STATE OF WASHINGTON
DEPARTMENT OF ECOLOGY

February 19, 2014

Re: Opinion Pursuant to WAC 173-340-515(5) on Proposed Monitored Natural Attenuation Work Plan for the Following Hazardous Waste Site:

- **Name:** Kelly-Moore Paint Co
- **Address:** 5410 Airport Way South, Seattle, WA
- **Facility/Site No.:** 2163
- **VCP No.:** NW2305
- **Cleanup Site No.:** 5064

GROUNDWATER ELEVATIONS	
MARCH 2011	
Kelly-Moore Paint Company Seattle, Washington	
By: AFS	Date: 10/17/13
Project No. 14697	Figure 4

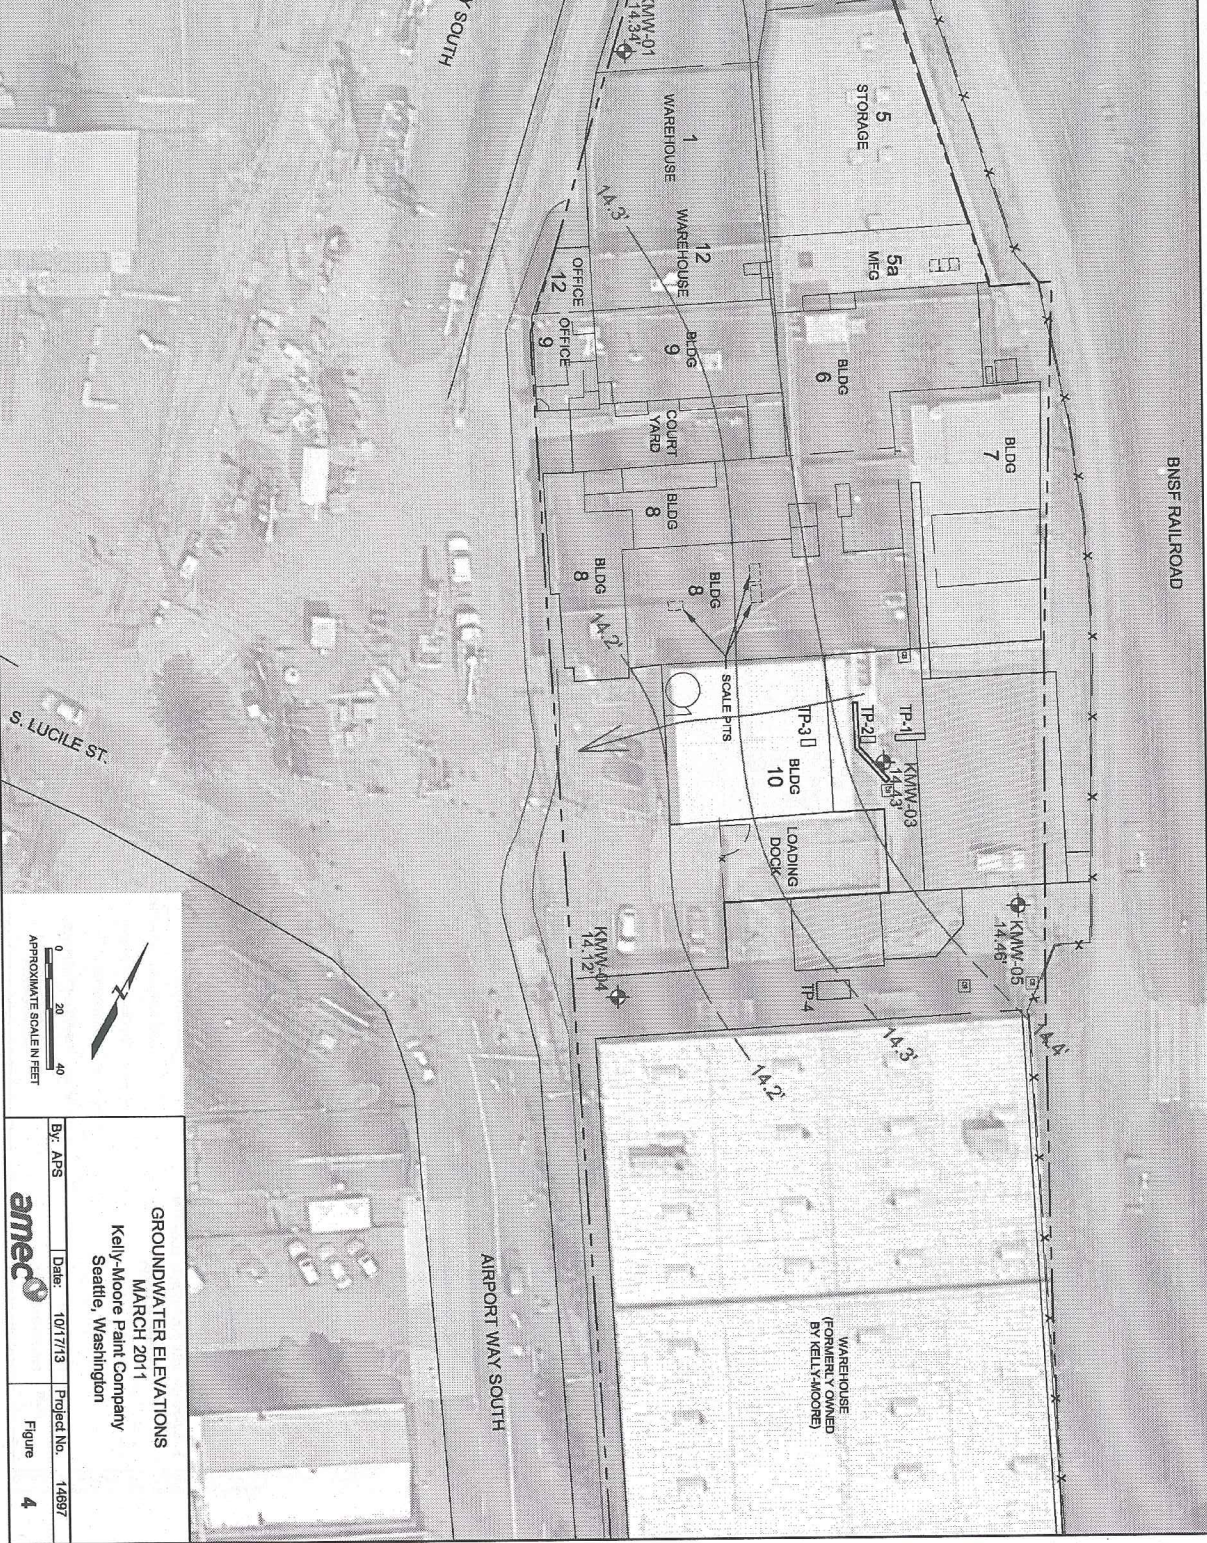
- Three different groundwater flow directions are provided in the work plan: west, west-southwest and southwest. One round (March 2011) is insufficient to confirm the previous (2003) estimated groundwater flow directions.

- On Figure 4, no groundwater elevation is plotted for KM-02 and it is not provided in the report.
- At the north end of the Property, TCE and vinyl chloride were detected in groundwater in soil borings KM-16 and KM-17 at concentrations exceeding Method A cleanup levels. AMEC states that additional sampling has shown that the extent is limited and may be an offsite source. This groundwater plume has not been fully characterized and adequate characterization of VOCs at the Site has not been sufficient to demonstrate that the VOCs have not comeingled with the gasoline plume.

**HISTORICAL GROUNDWATER
 SUMMARY RESULTS, GASOLINE
 NORTH AREA**
 Kelly-Moore Paint Company
 Seattle, Washington

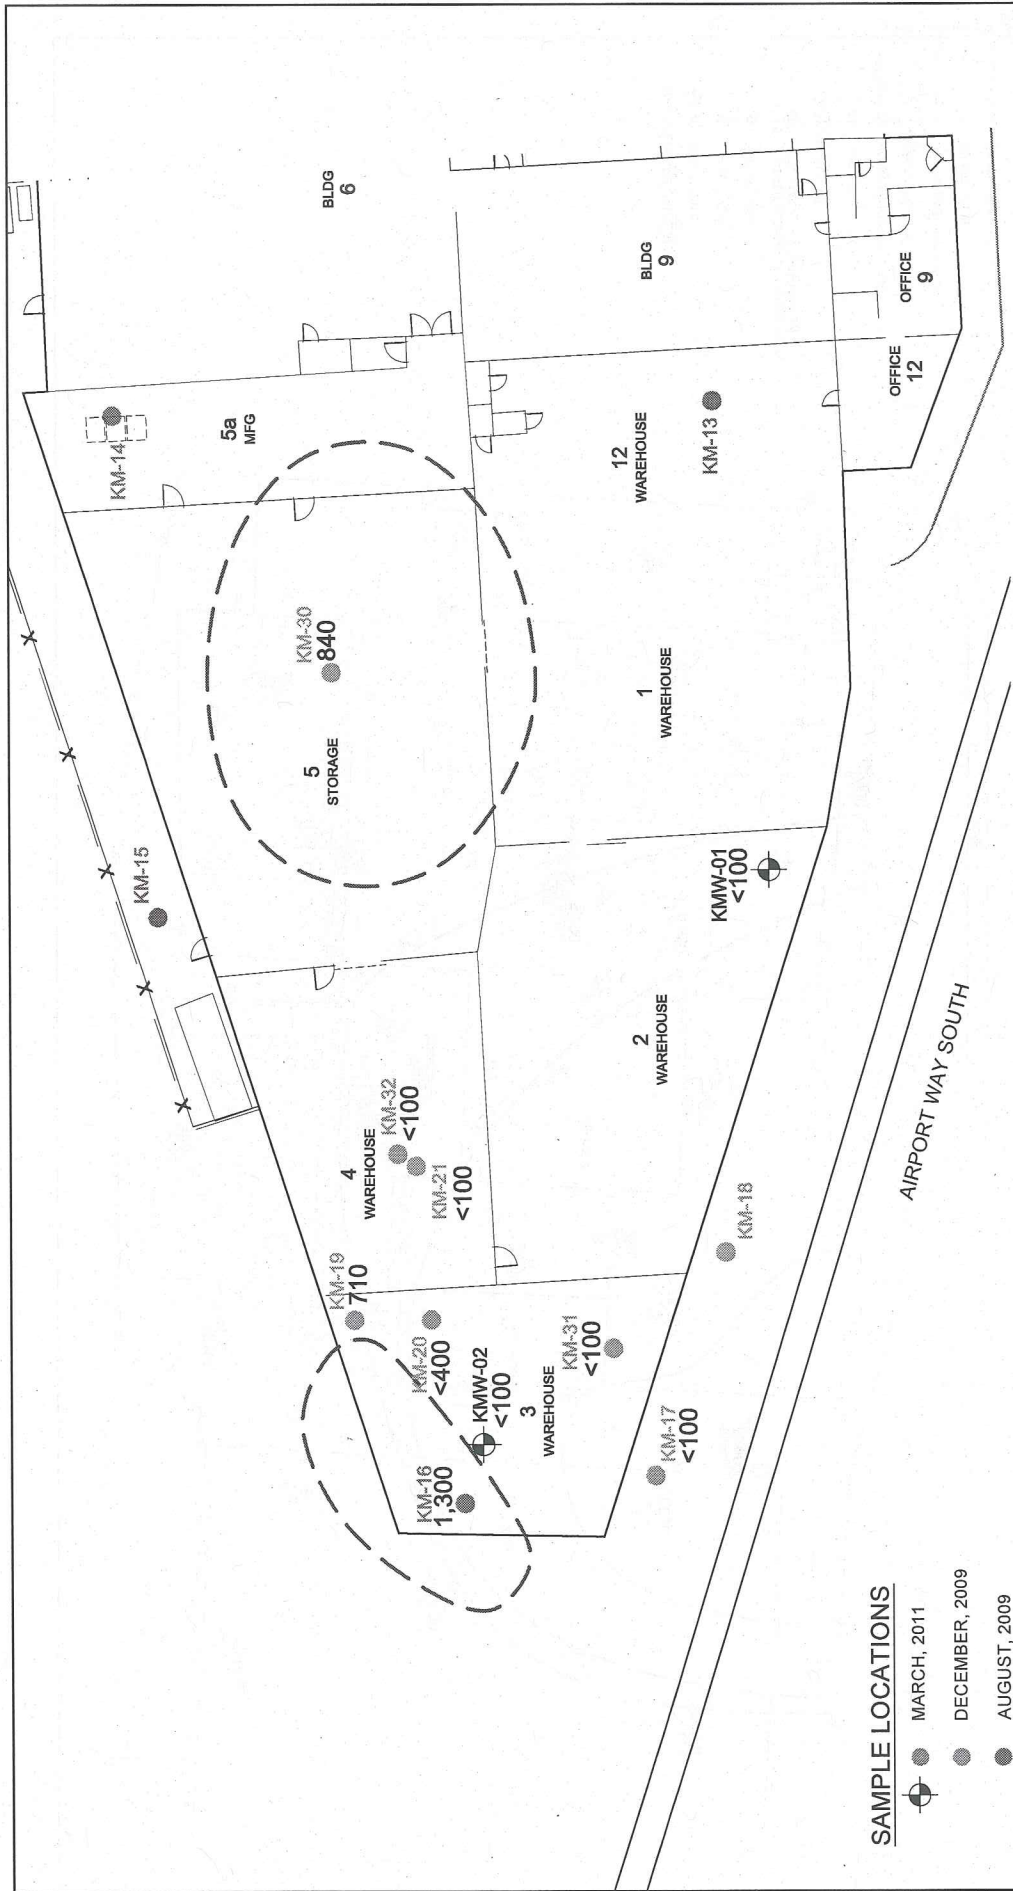
- The nature and extent of the groundwater contamination has not been fully characterized. The groundwater plume extends beyond the Property boundary to the south-southwest (Airport Way South) as depicted in figure 9, and possibly to the north (BNSF Railroad property) as depicted in Figure 8.

- Figure 8 depicts two separate unbounded gasoline plumes, in the vicinity of KMW-02 and your proposed new monitoring well KMW-06 as shown in Figure 12. Until these two plumes are bounded it is not known if these wells will be sufficient for data collection requirements of MNA. However, these monitoring wells can be used as a starting point for MNA data collection.
